Subject: Draft SAMA RAI Clarification Response
Creation Date: 2/13/06 3:55PM
From: <william.maher@exeloncorp.com>

Oyster Creek RAI Clarification Responses

Clarifications Needed in Oyster Creek SAMA RAI Responses

Figure 1c-1 Review Process for Oyster Creek PRA Model

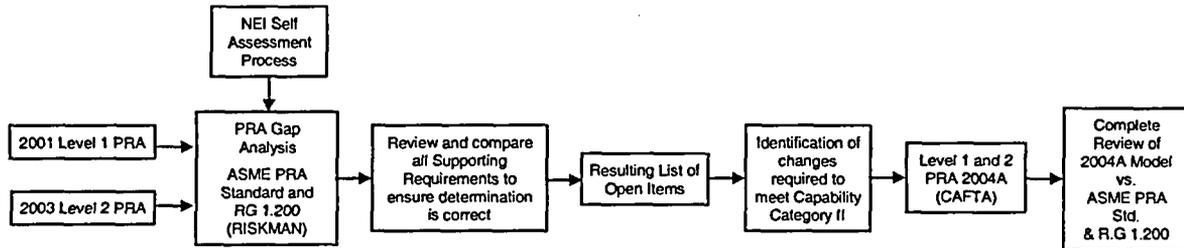
The response to this RAI indicates that the results of the 2004A PRA model were "re-reviewed to establish the number of gaps that remained following the update" and "the self-assessment performed for the 2004A model and documentation also applies to 2004B". Was the 2004A analysis subjected to a complete self assessment or was the focus of the re-review limited to those gaps found in the 2001 PRA? Of concern is the completeness/applicability self-assessment of the 2001 PRA relative to the 2004A model considering the extensive changes from the 2001 model to the 2004 model not the least of which is the change from support state (RISKMAN) modeling to linked fault tree (CAFTA) modeling.

The Oyster Creek 2004A model, documentation, and results were subjected to a complete self assessment to ensure that they reflected the insights from the RISKMAN model and the model changes made during the 2004A model preparation.

Following development of the 2004A model, it was then completely re-assessed using the Ref. [1] and [2].

Figure 1c-1 summarizes this process.
